BCA ASSESSMENT REPORT
SSD Design

PROJECT:
President Private Hospital
Redevelopment

Revision: 0

Date: 29 June 2020

Ground Floor Compartment Plan (Indicative)

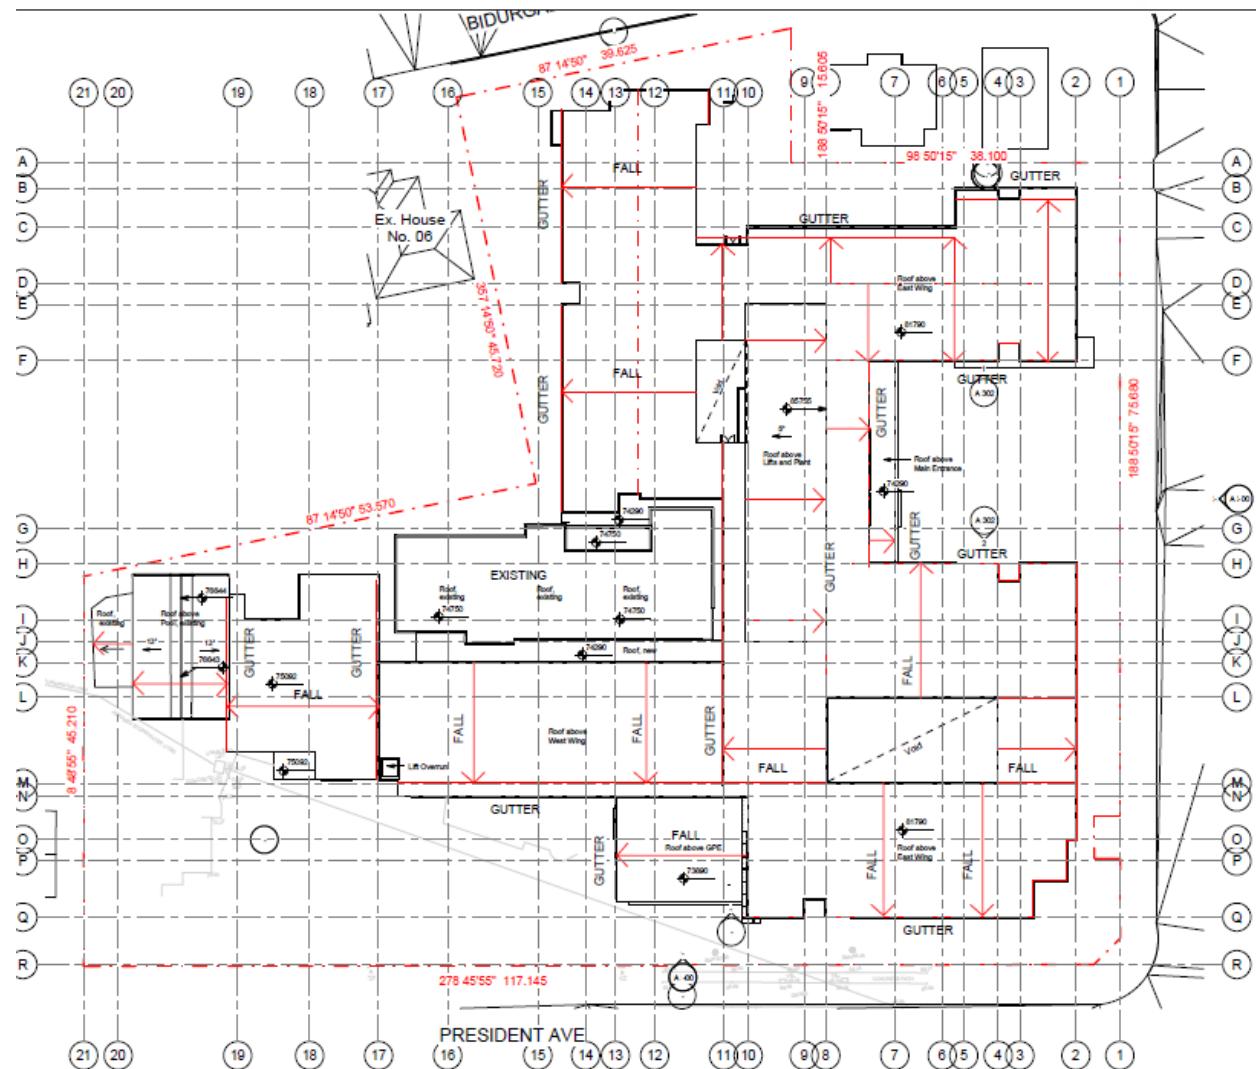
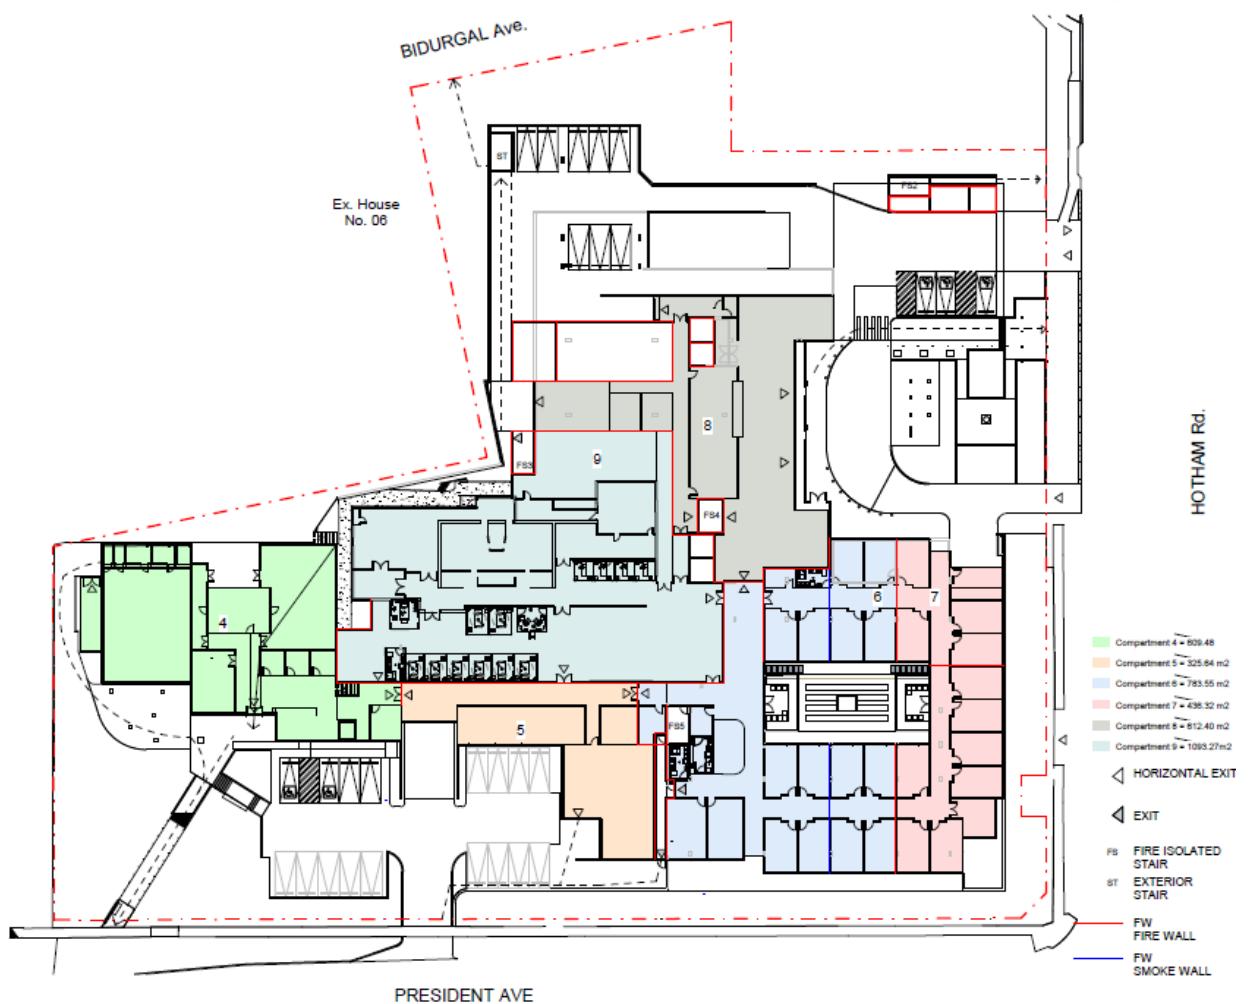
Patient care areas need to be separated into maximum 2,000m² fire compartments by fire walls having an FRL of 120/120/120. Non-patient care areas may be increased to maximum 5,000m² fire compartments.

Compartmentation is to be as follows:-

A. In Ward Areas –

- i) Where the floor area exceeds 1,000m², then it must be divided into compartments of not more than 1,000m², by walls with an FRL of not less than 60/60/60, and
- ii) Where the floor area exceeds 500m², then it must be separated into further compartments of not more than 500m², by smoke proof walls complying with the requirements of Specification C2.5, and

- B. Treatment areas must be divided into compartments of not more than 1,000m², by smoke proof walls complying with Specification C2.5.
